**TOWN OF BLIND RIVER
REQUEST FOR TENDER
NEW BLIND RIVER WATER TREATMENT PLANT INTAKE AND LOW LIFT PUMPING STATION
CONTRACT NO. PS-2026-01**

**ADDENDUM #9
March 13th, 2026**

STRUCTURAL DETAILS	S038
DATE: 2022.06.22		SCHEDULE	
DESIGNER: ERIC ESTRELLA	ENGINEER/ ARCHITECT: REBECCA PRINGLEMEIR	DRAWING No: Sched - Lintel - Block	Metric

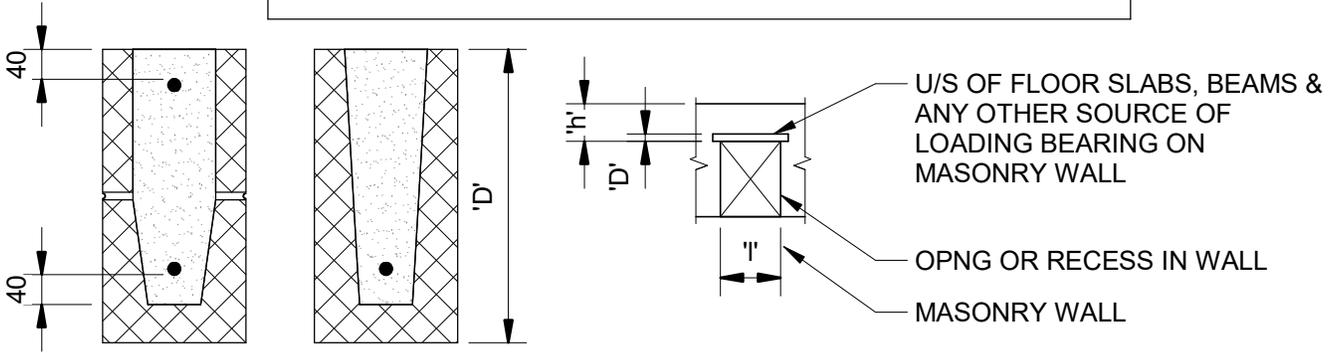
Q2: Lintels. Reference drawing S-702, detail 7, shows structural framing that spans openings between 2500 to 4600mm. Please provide lintel details for openings that span less than 2500mm.

A2: Contractor shall use S-702, detail 7 for openings from 2,030 to 4,600 mm. For spans less than 2,100 mm, contractor shall use grouted block lintel and galvanized steel lintel as shown on details S038 and S040 attached as part of this addendum (refer to Changes 4.1 and 4.2)

ArtFORMS®
KELLAMY 610R

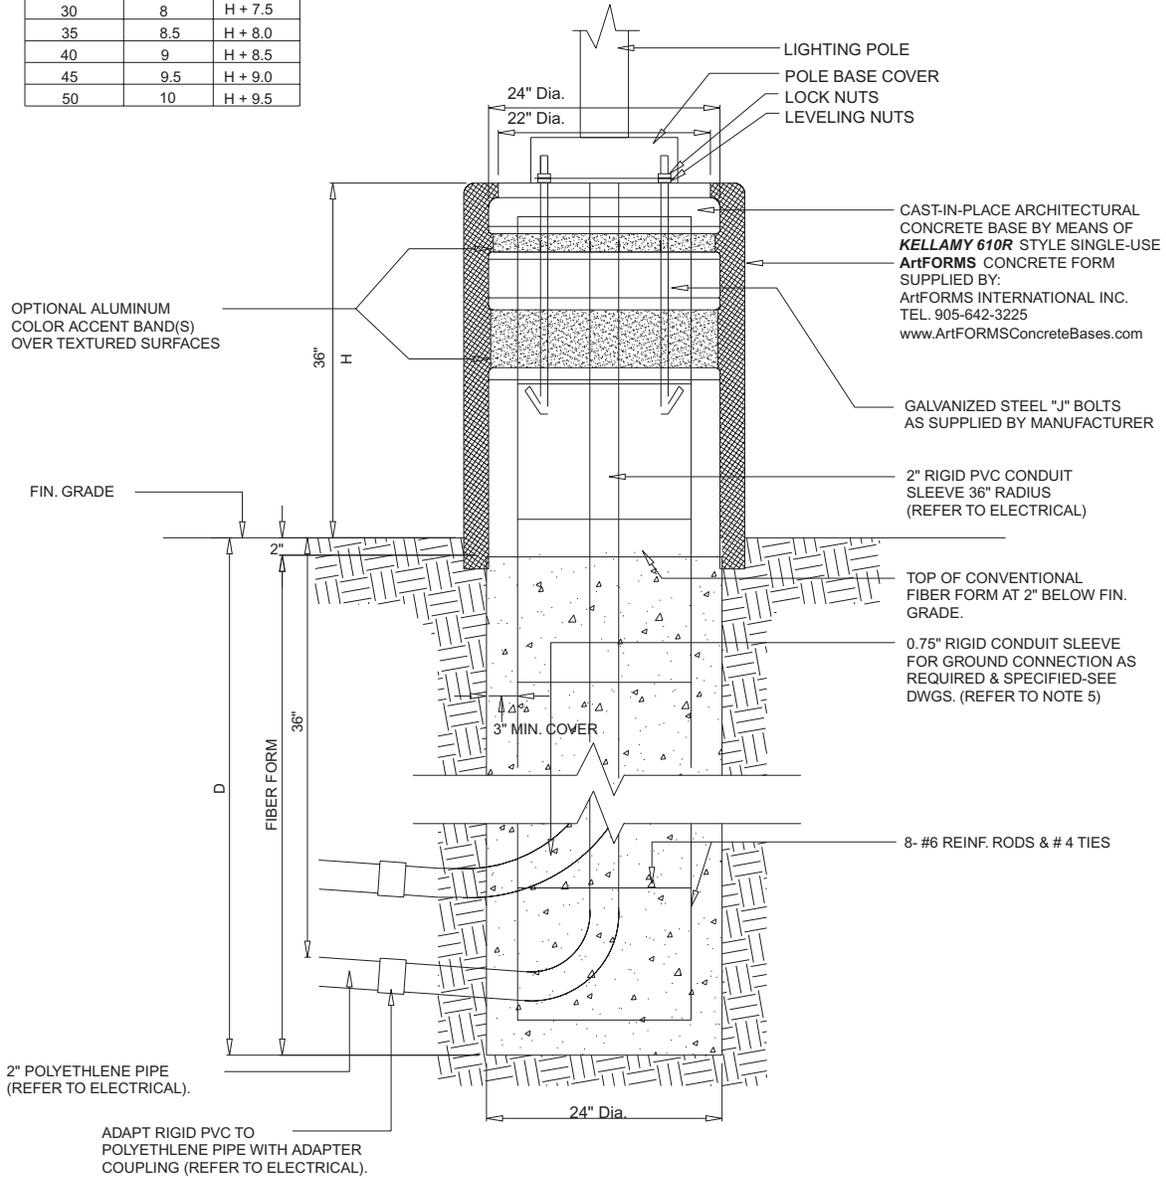
Q59: Reference drawing E-104, please provide rebar details for the lightpole base.

A59: The lightpole base is a prefabricated product by ArtFORMS®. Refer to the attached manufacturer detail in Appendix A for the Kellamy 610R base.
